**Subject** ▶ Change of Chuck

**For Models** ▶ HR2010 (Rotary Hammer 20mm)

**Description** ▶ As illustrated below, Chuck has been changed for improvement of installing bit.

## Note

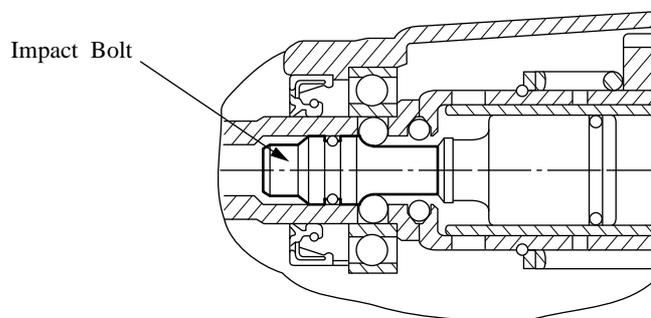
1) Impact Bolt should be put in the place as illustrated below.

2) Leaf Spring 26 can be removed by retaining ring plier.

3) Steel Ball 7.0 has not been changed.
